## Groundwater Application Review Summary Form

Application # G- 18534

GW Reviewer Jen Woody Date Review Completed: Oct 5, 2017

**A. GENERAL INFORMATION:** Applicant's Name: Scott Baldwin/DePonte Cellars, LLC County: Yamhill

Figure 2. Well Location Map

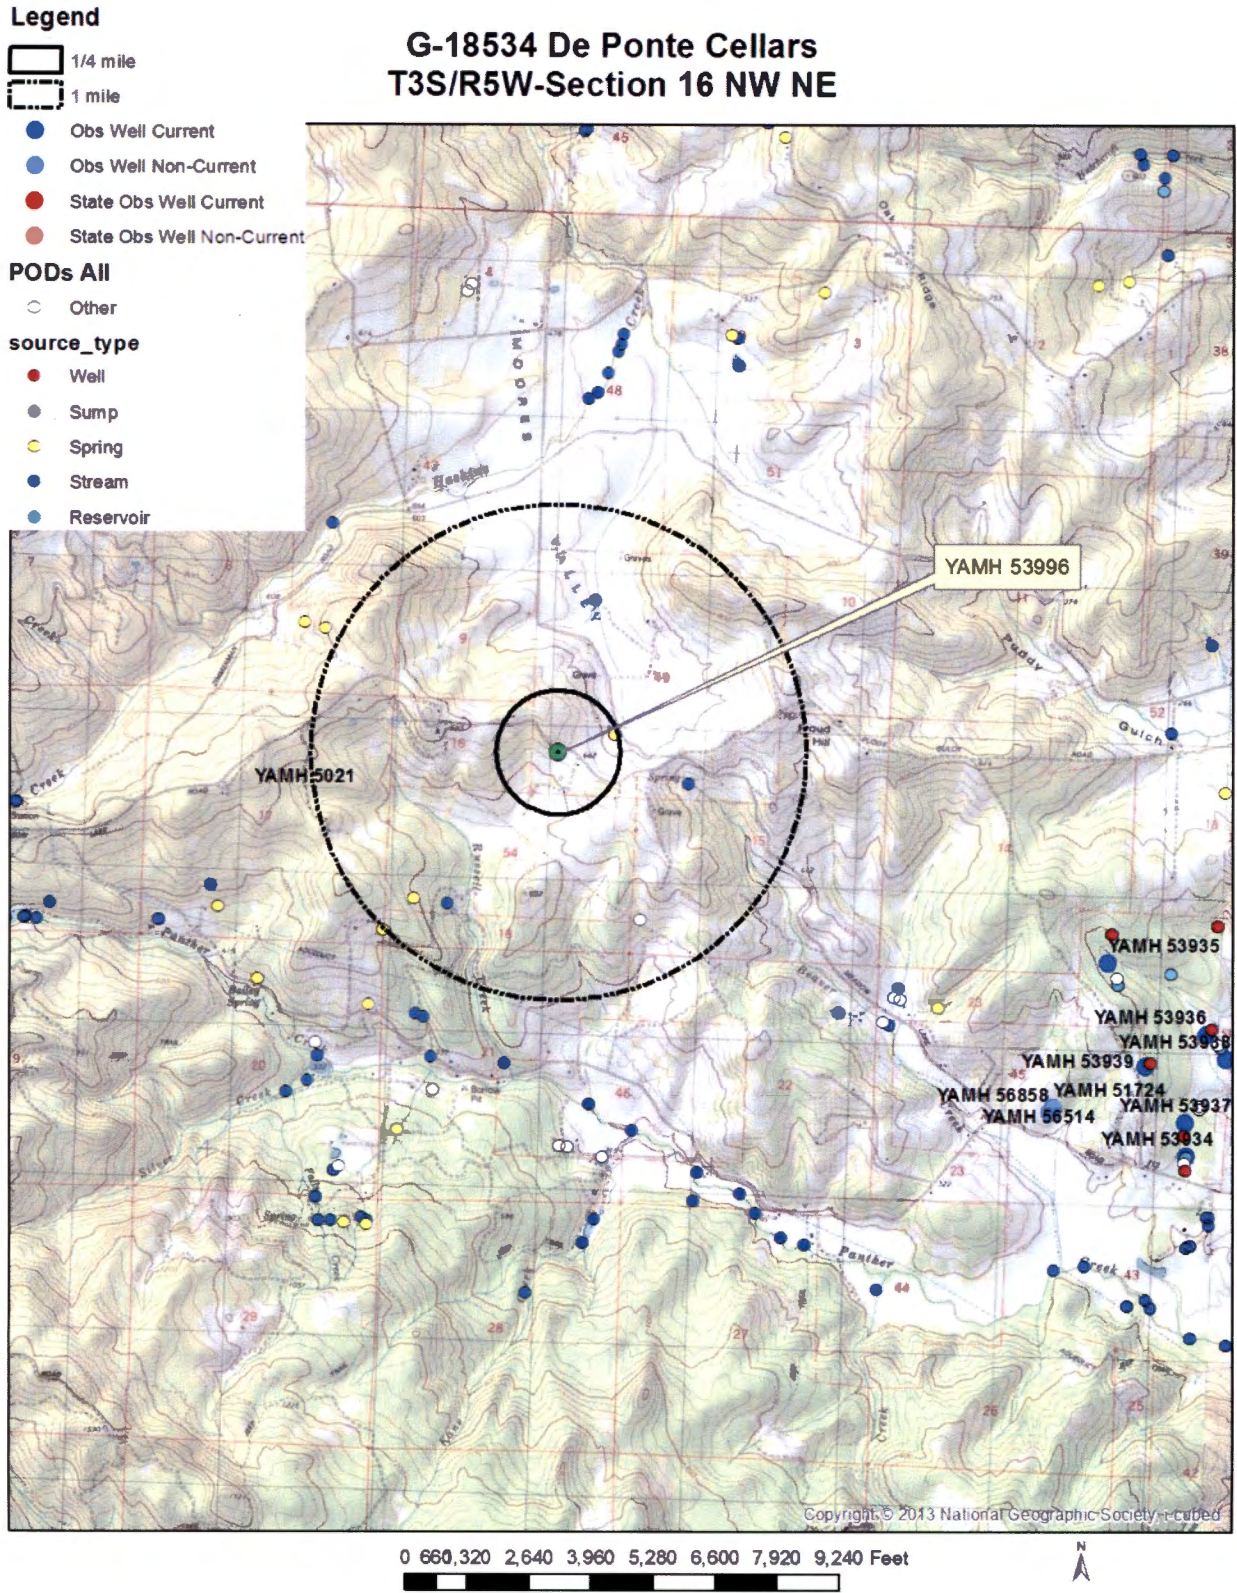
**Basis for aquifer hydraulic connection evaluation:** Water-table maps, where they exist, generally show flow paths that converge on local perennial streams. The water level at the subject well is above perennial reaches of the nearby creeks, and the creeks have incised through several hundred feet of marine sediments. Groundwater from the uplands likely discharges to surface water down-gradient, providing baseflow or spring flow to sustain nearby perennial reaches of the creek.
